56 kilobaud modem bug report (1-10-88)

TRANSMITTER ENCODER BOARD (110386):

MODIFICATION OF THE TRANSMITTER ENCODER BOARD

FIG. 1

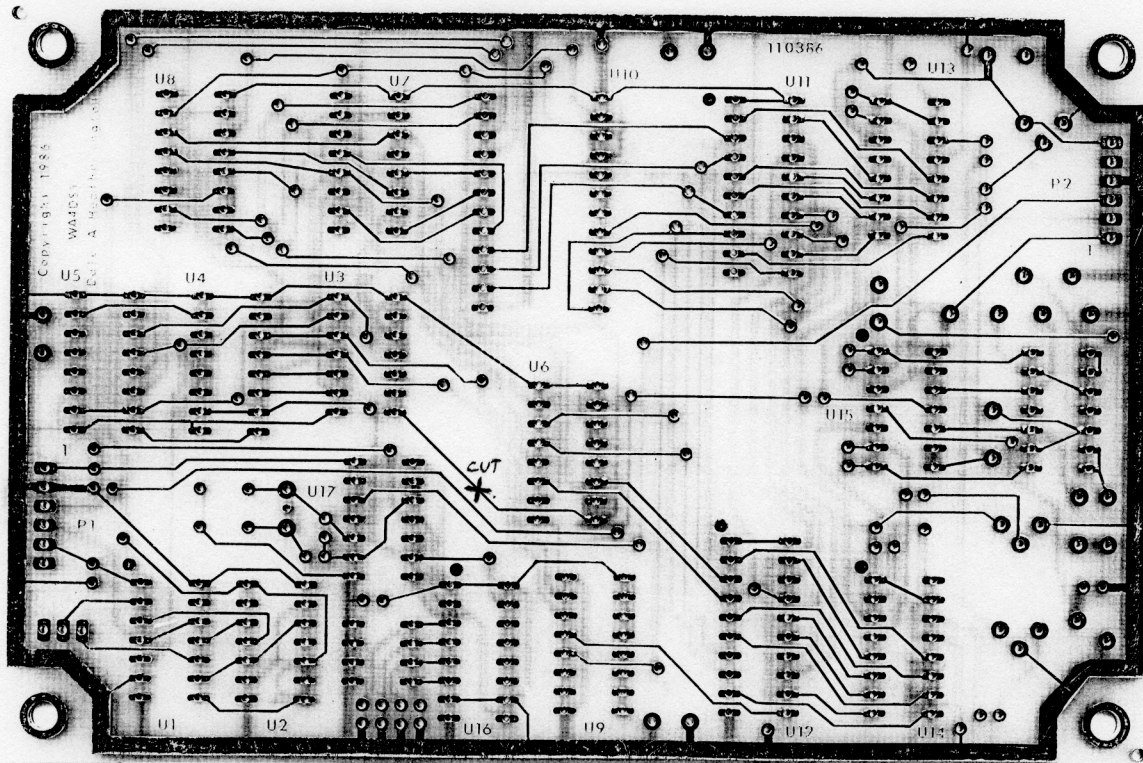
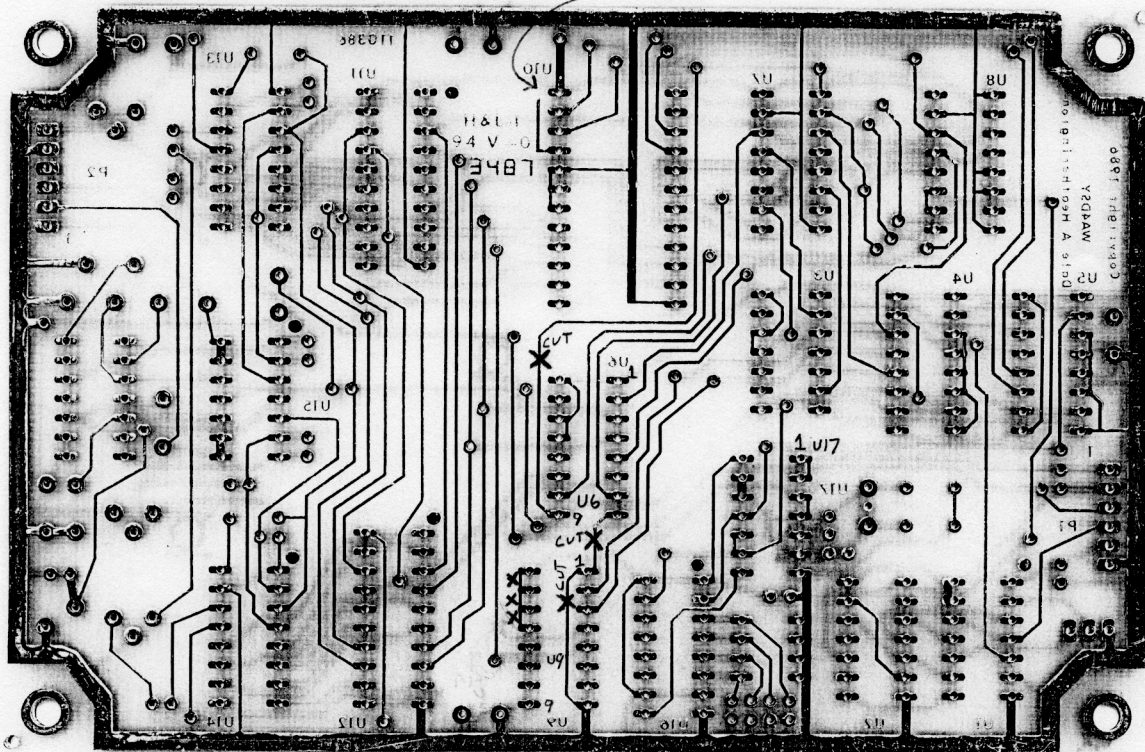
The second problem is more difficult to correct. Many of the 74HC163 counter chips have small timing skews in their Q outputs. This results in glitches on the outputs of U3 (74HC30) and U9 (74HC139). These glitches cause the latches U6, U11, and U12 to be loaded at the wrong times, thus wreaking havoc on the output waveforms. The fix for these troubles involves gating these strobes with the clock. The unused half of U9 is used for this purpose. The following is a step by step description of the trace cuts and jumper wire installation.

1. Cut the traces indicated on Fig. 1
2. Connect the following pins with jumper wires

1 Trace cut

1-10-88 bug report: Add missing Trace here

U3-8 to U7-1

U3-8 to U9-13

U6-8 to U9-8

U9-9 to U9-1

U9-11 to U6-9

U9-14 to U16-15

U9-15 to U17-11

GLITCH FIX MOD. 9-24-87

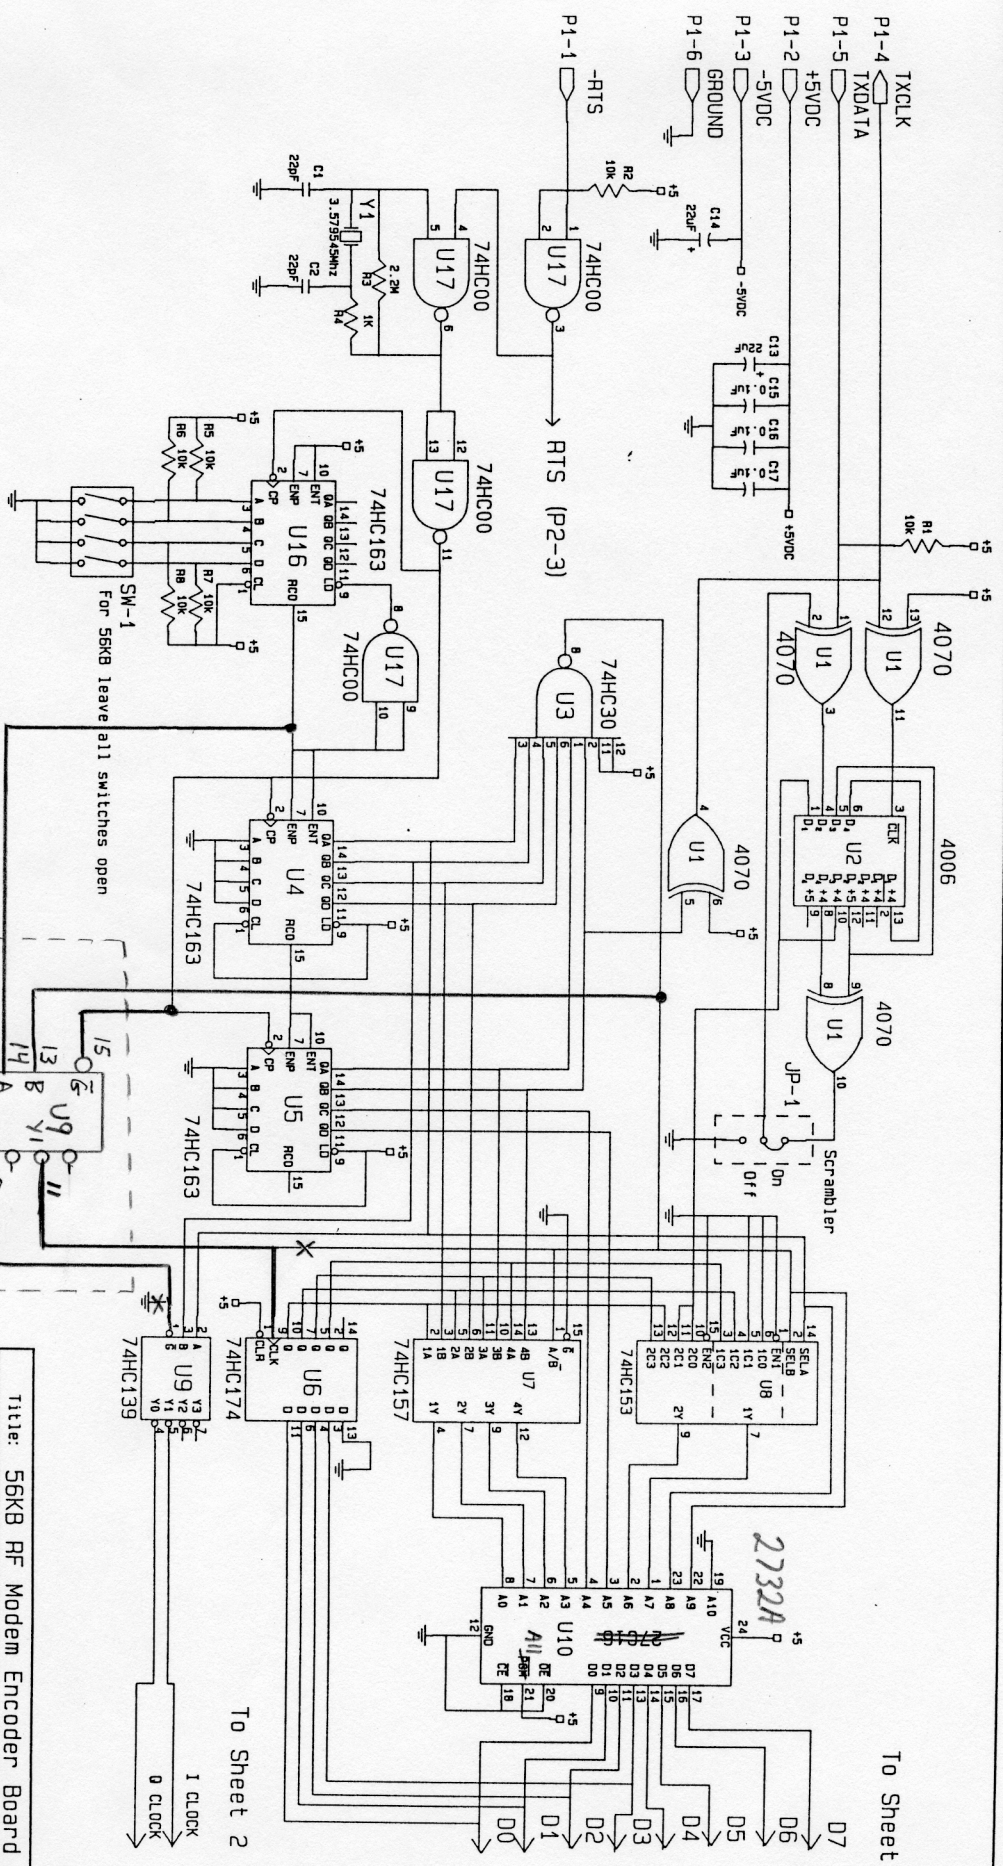
6 Traces cut
